Richard Wolper, representative for JOVID Mark Hotel and Event Center, is requesting an amended conditional use and site plan approval for a hotel on approximately 11.74 acres. The proposed density for the hotel has not changed from the previously approved 250 individual condo/hotel units. The project includes a restaurant, spa, ice skating rink(s) and conference center. The request has changed the layout, architecture and number of stories. The proposal is located between Highway 248 and Peace Tree Trail with frontage and access on Peace Tree Trail and south of the Iroquois phase 2 units and more specifically located in Section 6, Township 2 South, Range 5 East in the JBOZ (Jordanelle Basin Overlay Zone).

RE: Iroquois Hotel Site, CUP, Revised Plan Approval 2<sup>nd</sup> Review

Subject: Geotechnical Review No. 6  
Black Rock Ridge, JOVID Hotel  
Browns Canyon Road and Highway 248  
Wasatch County, Utah  
Project No. 1141138

**SITE RETAINING WALL SECTION**  
SCALE: N.T.S.

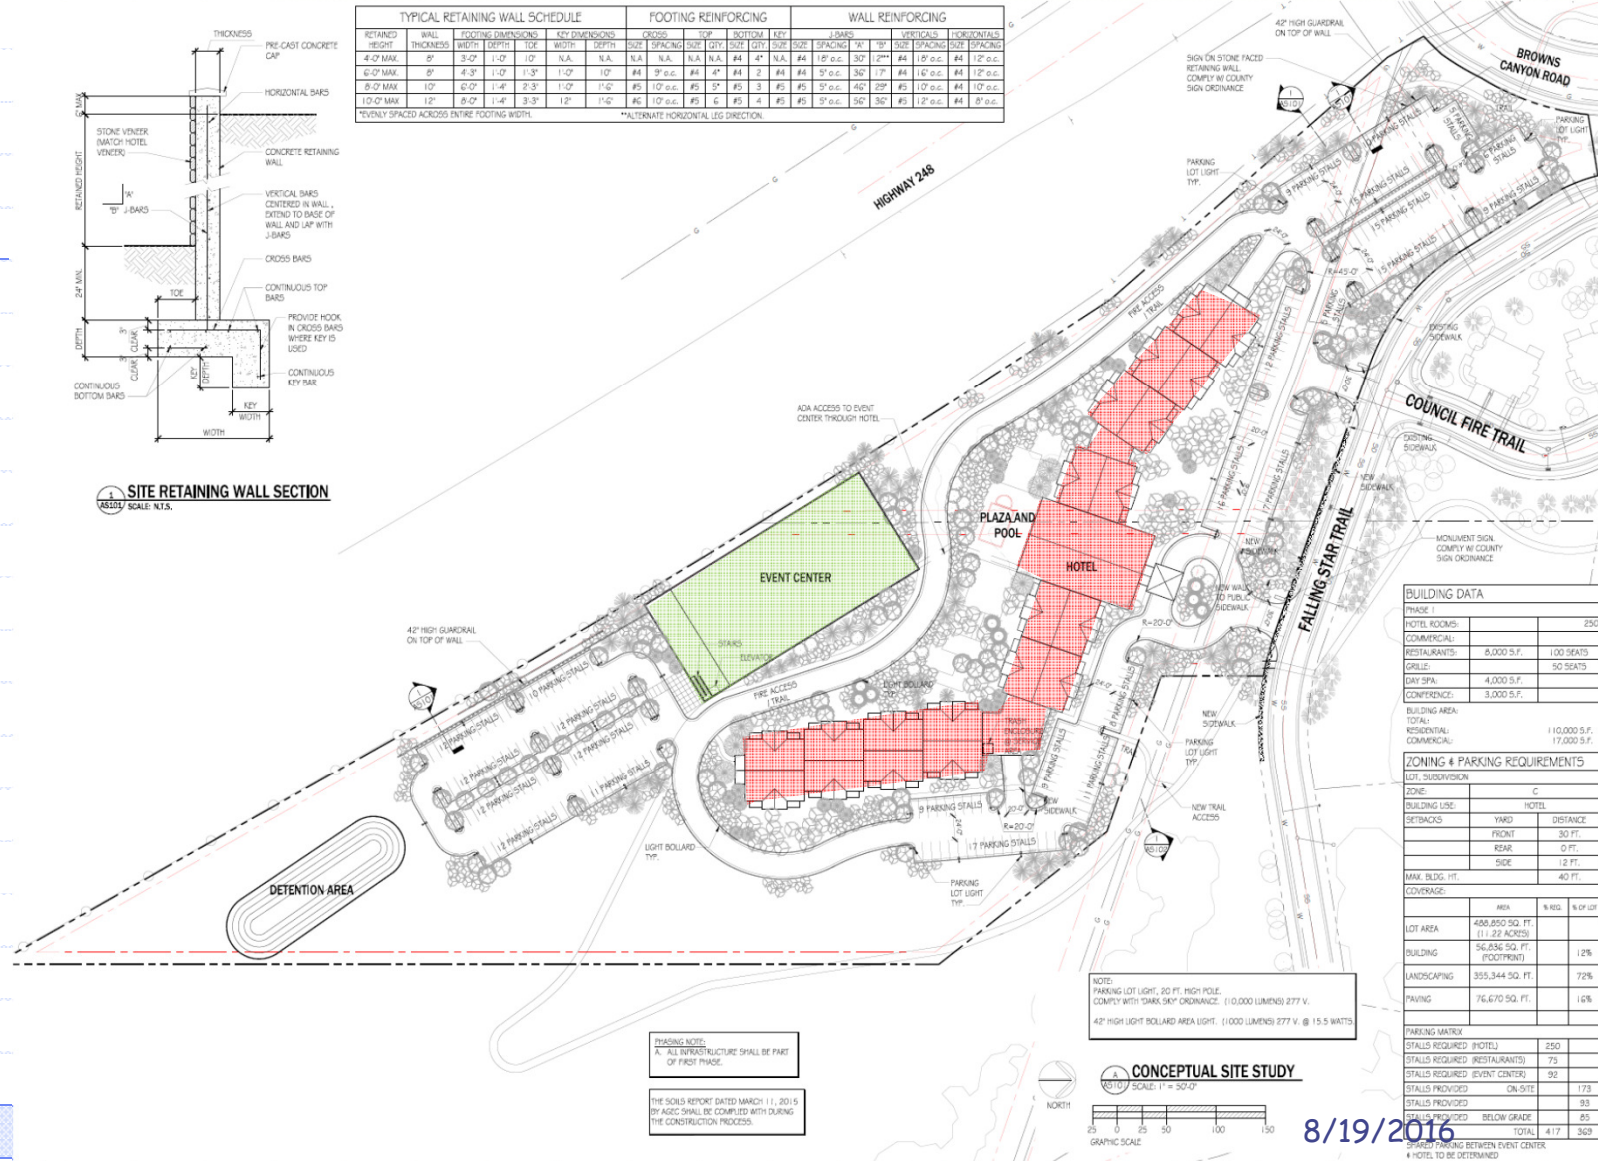
2. The Planning Commission will need to determine that findings for conditional uses listed in Section 16.23.07 (below) have been met.
3. All retaining walls must have a step at no more than a 10' interval. *The civil drawings show heights of retaining walls no greater than 10 ft. We added a detail of retaining walls and design on revised Sheet AS101.*

4. Retaining walls are vertical. Treatments for retaining walls need to be shown. Are they faced? *See revised detail on Sheet AS101. Walls will be faced with stone veneer.*

# Parking Demand:

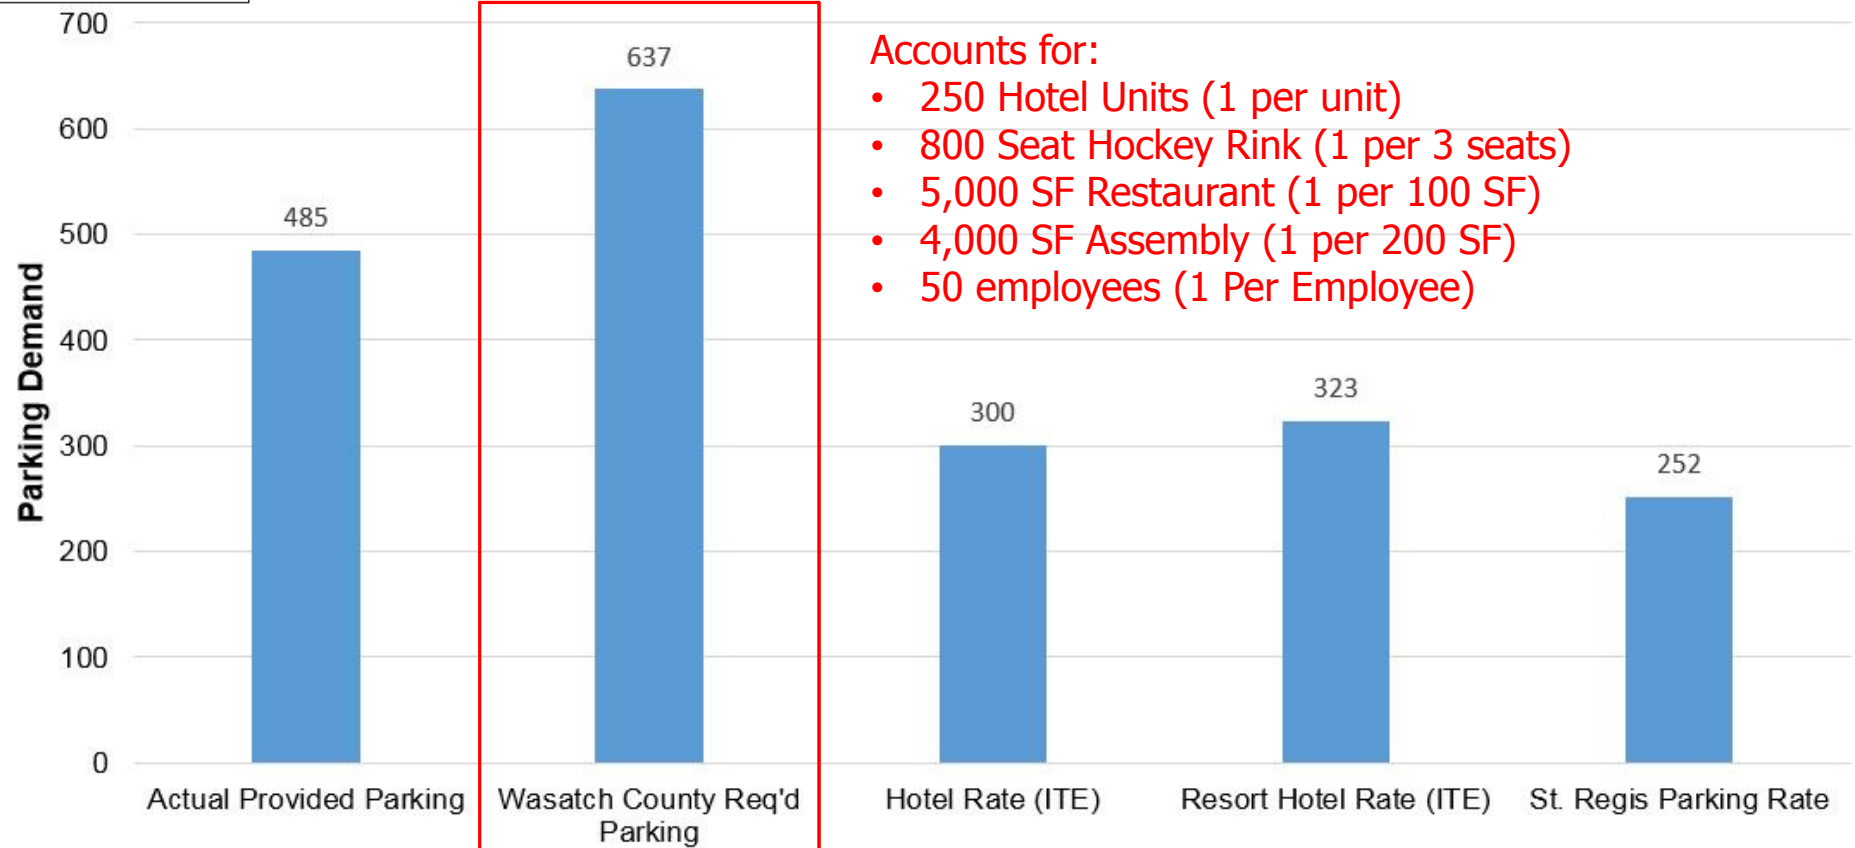
Staff agrees that there will be a large number of hotel patrons that use the hotel amenities and that there is justification for shared parking and reduction of parking stall numbers. Shared parking however, is only an estimate. There is no data to determine if the parking provided will be adequate or not and parking on the public streets in the neighborhood should not be an overflow option. Therefore there should be a requirement in the development agreement that parking is monitored on a phased basis and additional parking or other options (off-site parking and shuttles for events) could be required if the need arises.

Comments: Do we have any standard for shared parking? I appreciate the explanation given, however, there should be some standard that has worked in other places. The parking is listed as per owned room. there must be a prohibition on additional keys then for the proposed parking to work. That will need to be on the plat and recorded. Lower loop road does not meet County Standard. All lighting must meet current County Standard.

8. If phase 1 meets the parking requirements of the code for all individual uses including hotel, event center, commercial etc. proposed within phase 1 without the need for using shared parking. At the time of phase 2 approval the county will do a parking study performed by an engineer of counties choice using the developer out-of-pocket account. Additional studies may be required on future phases if parking becomes an issue. Any conflict between the planning department and the applicant regarding parking numbers will be reviewed by the Planning Commission. It should be noted that hotel parking is (1) stall per unit. Condo parking is (2) stalls per unit. (agreed in theory)

# Roof Plan:

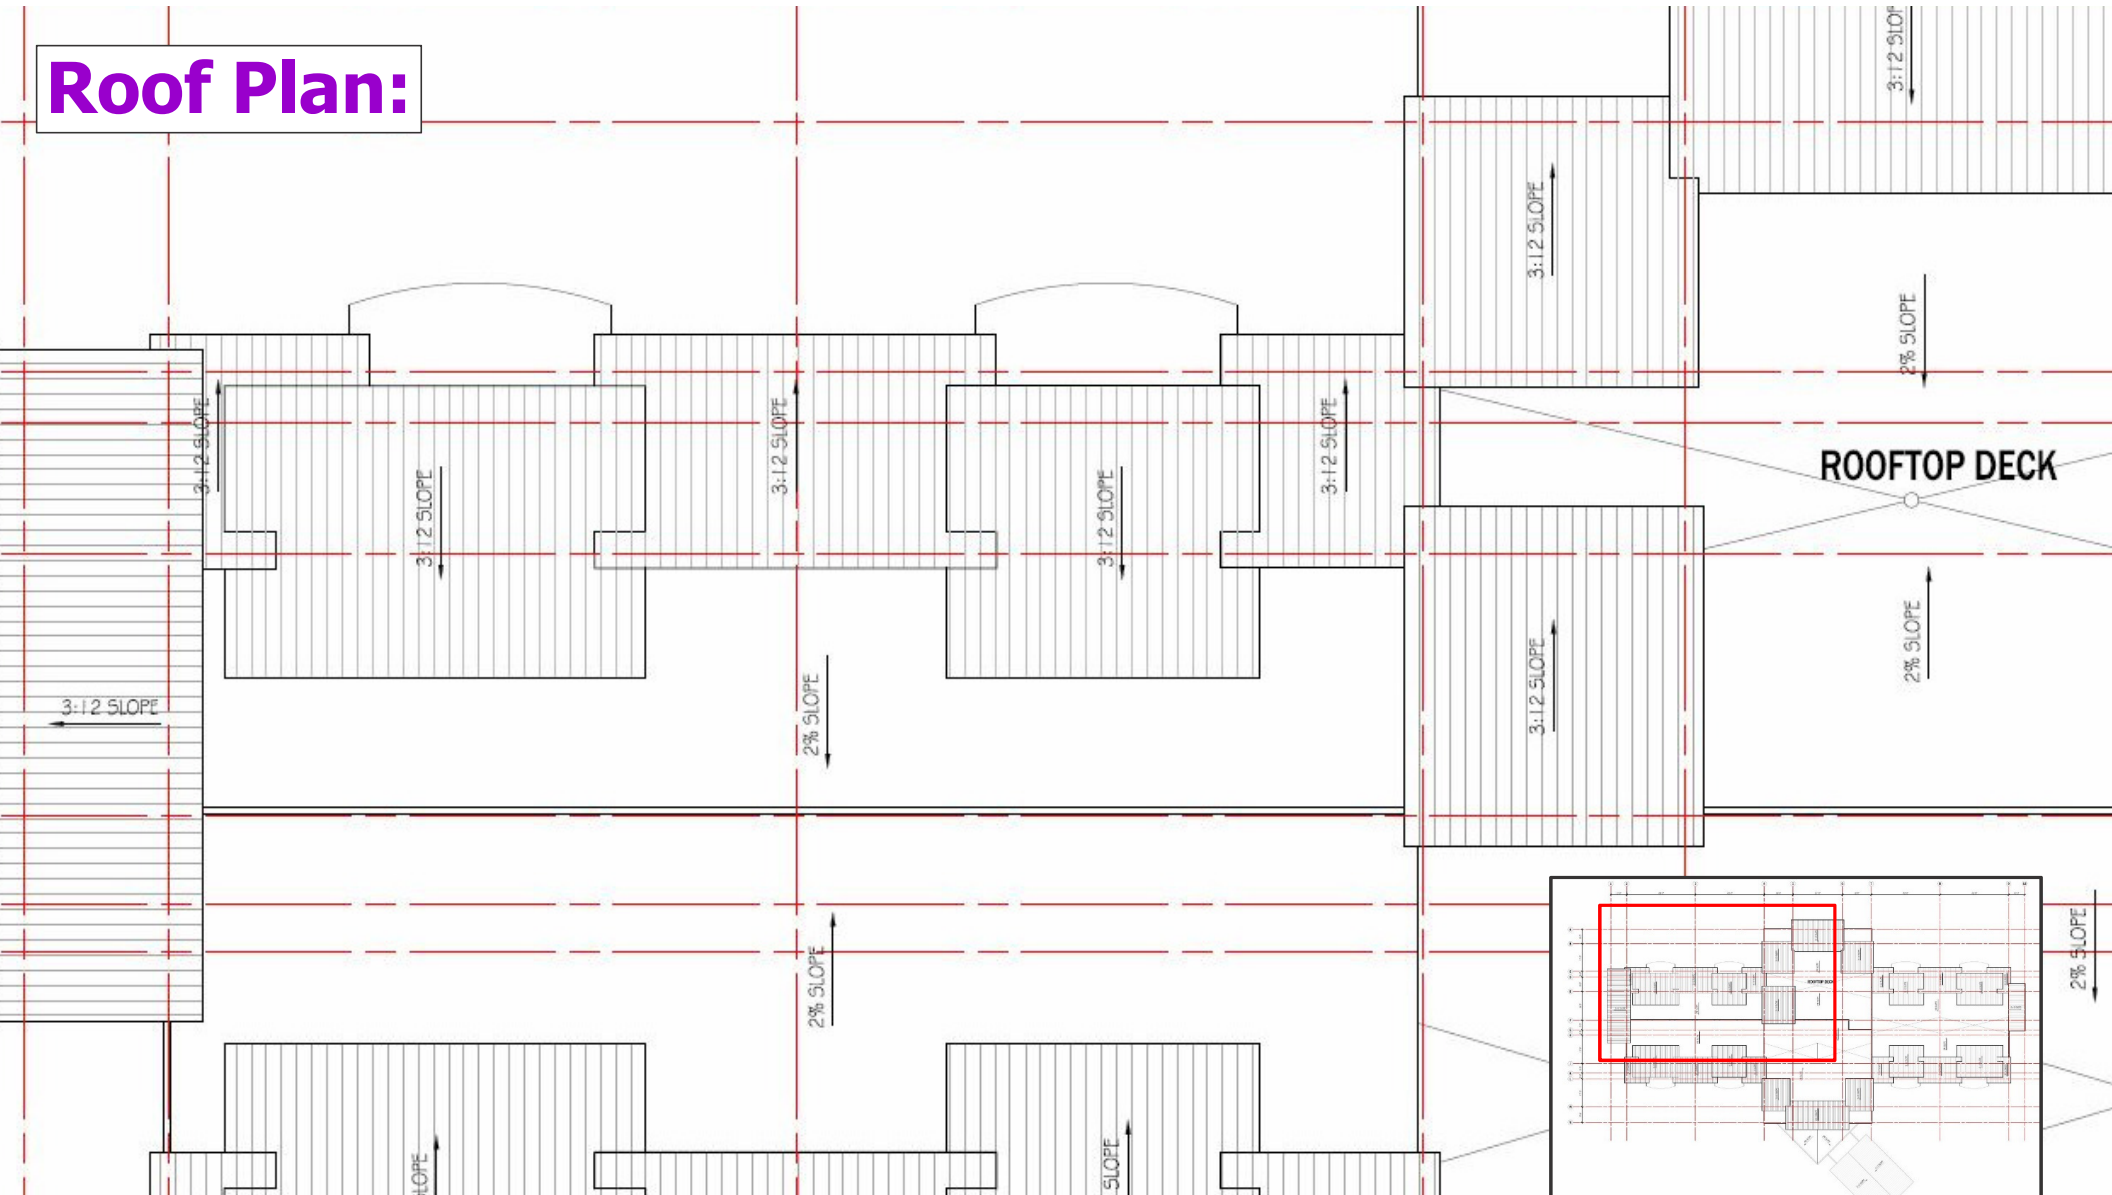
- 11. Demonstration that Section 16.15.15(E) of the code has been met regarding relief/breaks in long building facades. (Completed)
- 12. The JLUP (Jordanelle Land Use Plan) discourages large flat roof segments. A roof plan should be provided or some means to demonstrate that the proposal complies with the code. (Provided for review by the Planning Commission)

# Trail Cross-Sections:

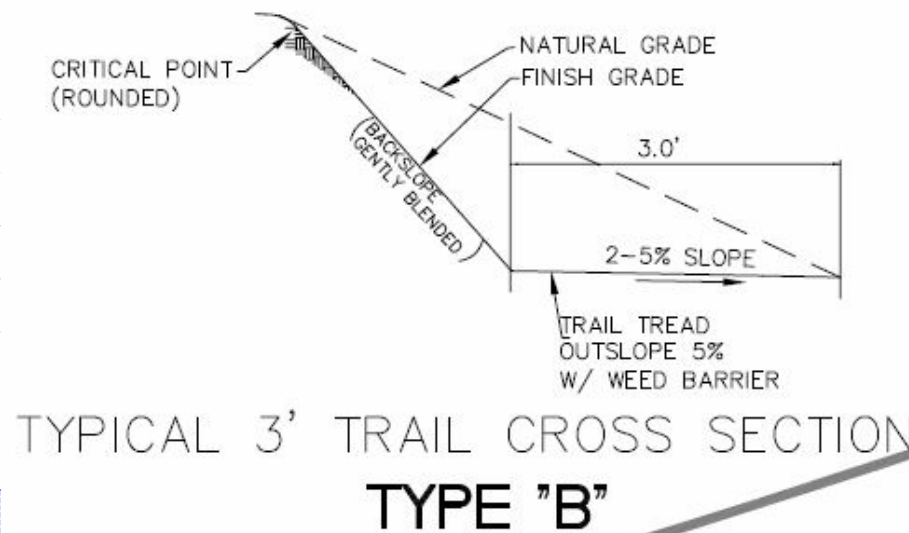
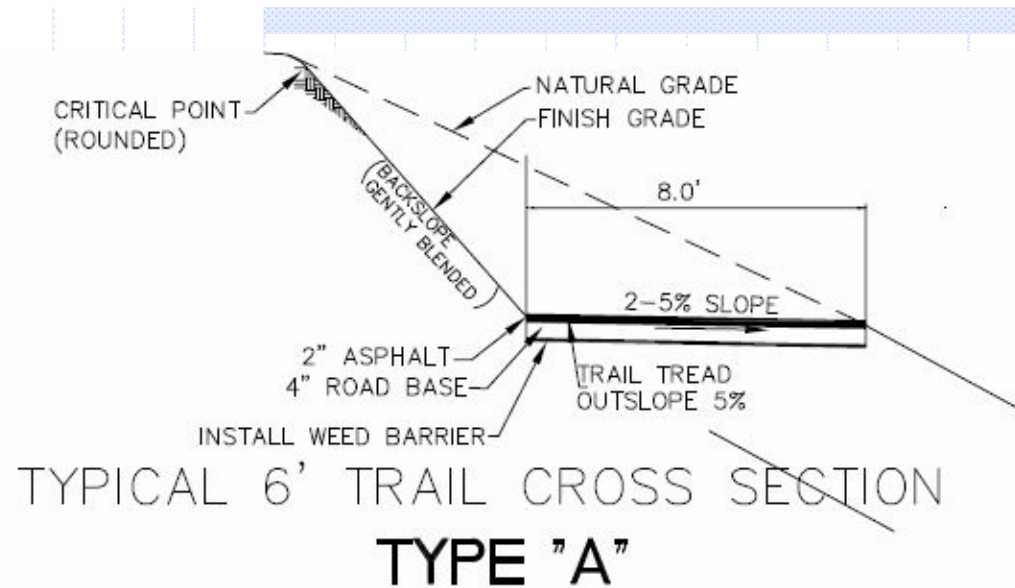
13. Weed barrier on trails need to be included in the cross section. *Refer to revised AS102, attached.*
14. The soils report dated March 11, 2015 by AGEK must be complied with during the construction process. *We have added this note to revised AS101, attached.*

## Proposed Planting Plan:

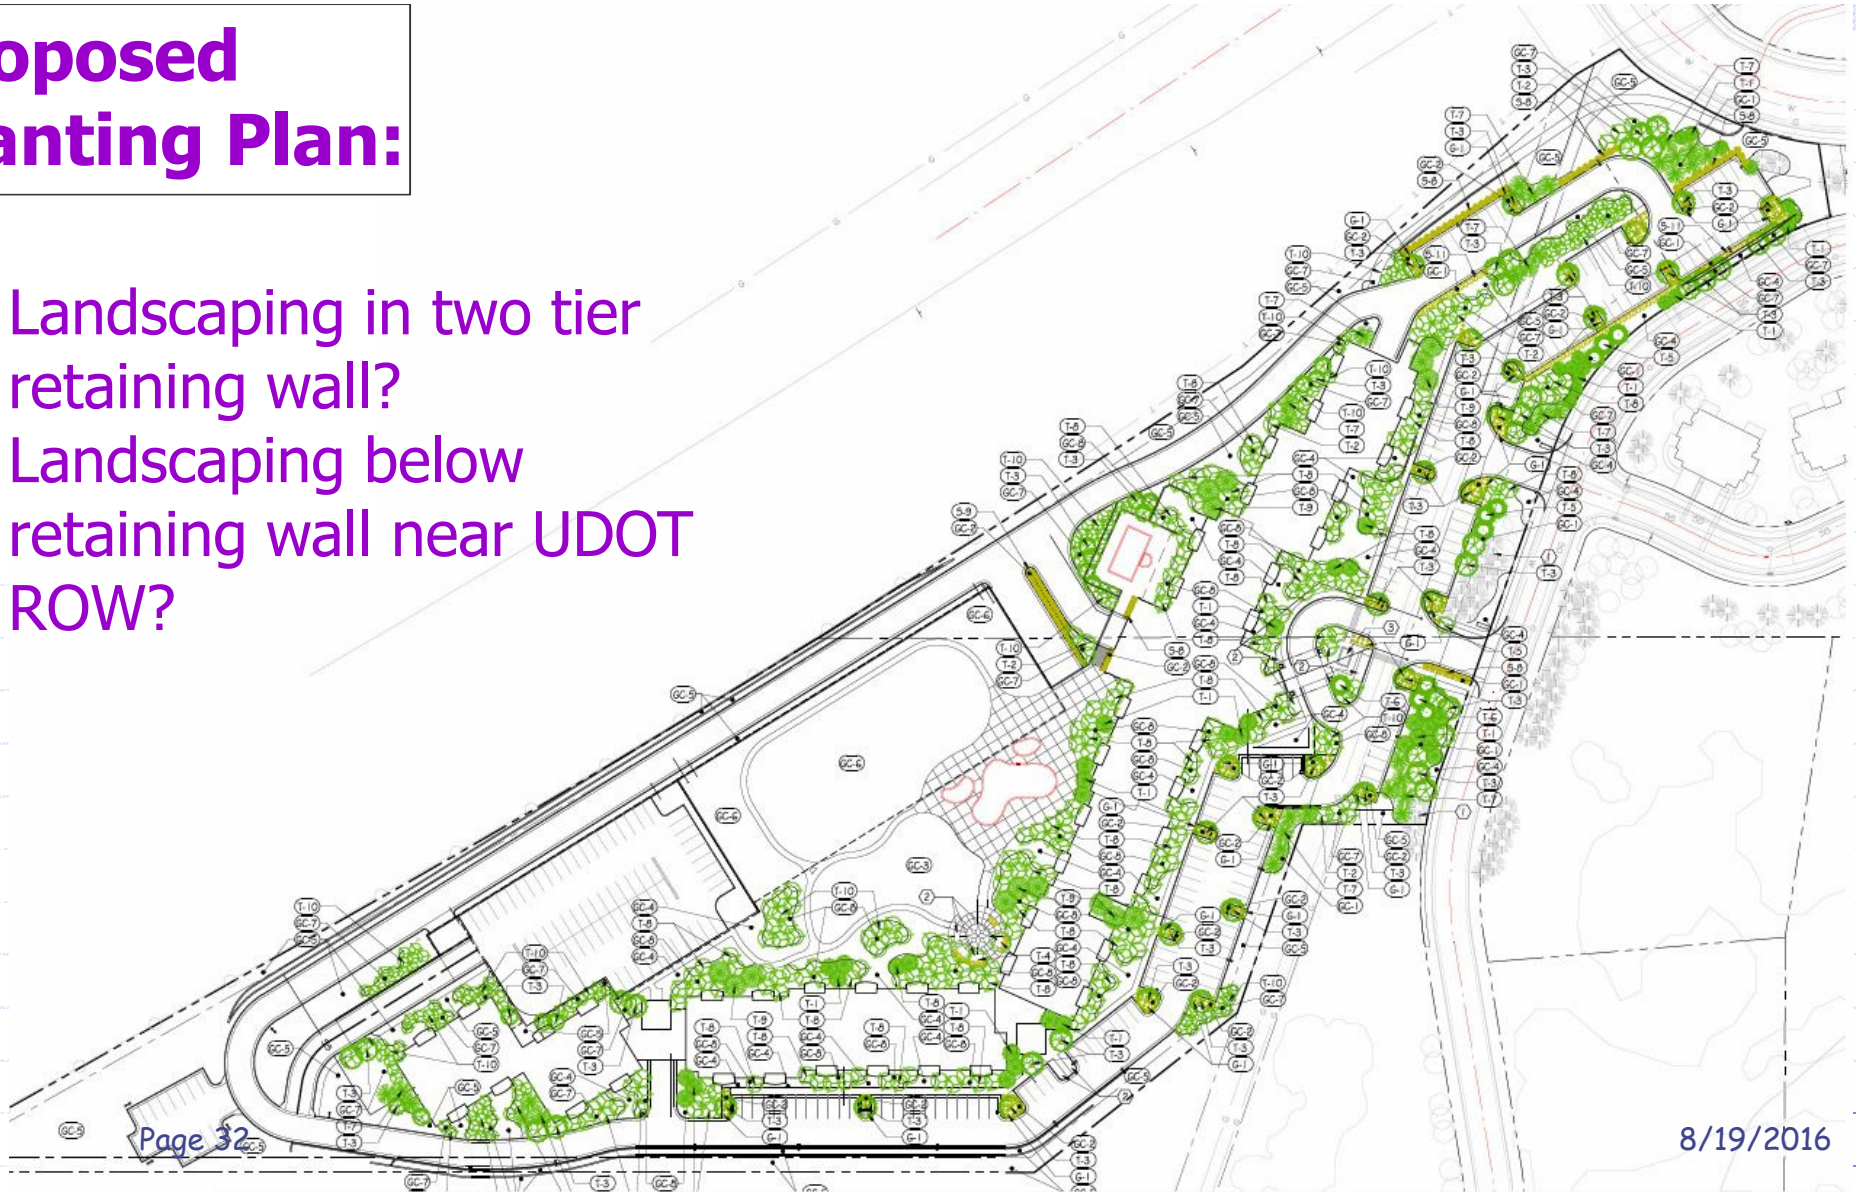
- Landscaping in two tier retaining wall?
- Landscaping below retaining wall near UDOT ROW?

9. Landscaping in front of the event center and practice arena and below the retaining wall on the UDOT property to break up the 10' retaining wall, event center and practice arena. The exposed portion of the event center is 40' tall. Landscaping in retaining wall benches in compliance with the code. (Agreed in theory)
